Powell Corridor Recommendations

Prepared by the Vancouver UBC Local Committee of HUB Cycling

Figure 1 - Current gaps shown in red

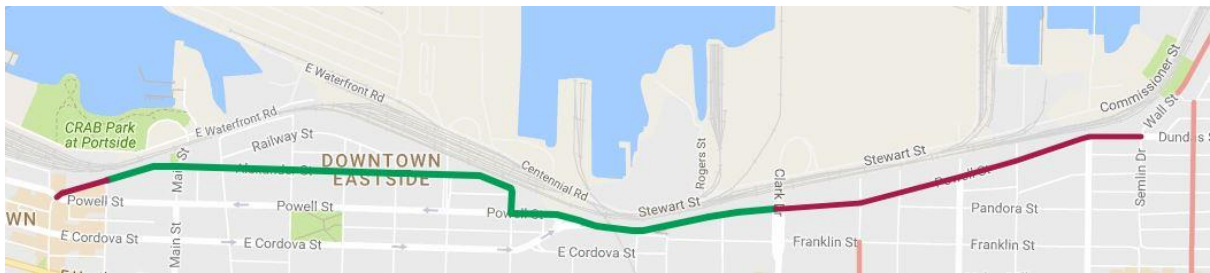
- 1) At the western extent of this route, the block of Alexander from Carrall to Columbia is signed as being one way for vehicle traffic. This connector is routinely used by people on bikes, in both directions. Designating the block as permitting two-way bicycle traffic, as is done on 5th Avenue between Cambie and Yukon, would provide a significant benefit, and provide a connection through to the Carrall Street Greenway, as well as to pending future improvements along Water Street. This section is shown in red on the left side of Figure 1.

- 2) Along Alexander Street, the route requires minor improvements and marking as a local street bikeway. The road is rough in sections which may serve as a deterrent for cars but may also do the same for cyclists. Regardless of whether surface treatment improvements are made, consideration should be given to signing this section with a 30 km/hr speed limit. This section is shown in green in Figure 1.

- 3) At the corner of Hawks and Powell, additional safety markings are required. Consideration should be given to signing the intersection as No Right Turn on Red for westbound vehicle traffic on Powell. The danger here is to eastbound bike traffic from Alexander which must cross the path of turning vehicles to access the protected bike lanes along the north side of Powell.

- 4) From Clark Drive to Wall and Semlin, a direct connection is required. This is shown in red on the right side of Figure 1. This direct connector should be included in the future rehabilitation of Powell Street. In the interim, a bypass is required given the heavy and fast moving vehicle traffic on Powell, and the current use of pedestrian sidewalks by people on bikes who are intimidated by the vehicle traffic. Options for this bypass route were the subject of a recent HUB Cycling assessment ride, and are discussed in this document.

Figure 2 - The Powell Corridor with proposed improvements

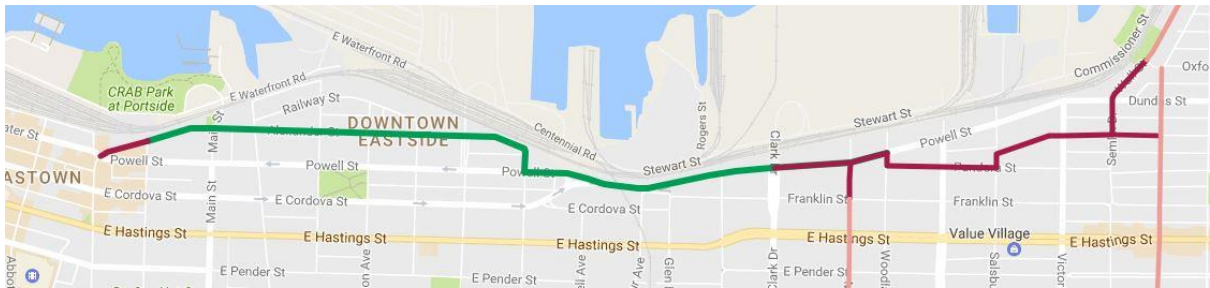
Figure 2, above, shows the areas of this route requiring improvement, with a proposal for the location of the Powell Street Bypass at the east end of the route.

The block of Alexander between Carrall and Columbia is an obvious connector, and requires only signing to permit two-way bicycle traffic.

The bypass route needs to be close enough to Powell to attract riders, many of whom will see it as a detour, making their trip longer. Starting at Clark, it is recommended that a bidirectional bike path be built in the road allowance, on the current sidewalk, on the north side of Powell. This is not ideal, but provides the best balance of a reasonable connection to a bypass route, with consideration of pedestrian users of this section. This section would provide a direct connection to the protected bikeway west of Clark, which is on the north side of Powell. Shifting the bypass route on to Franklin at Clark is not considered feasible, due to the difficulty in crossing Clark Drive where the overpass from the Port joins Clark.

It would not be sufficient to simply mark the sidewalk on the north side of Powell in this section as being open for use by people on bikes. The path should be widened, street furniture relocated, transit stops considered, driveways marked, and then the path marked for use by both people walking and people on bikes.
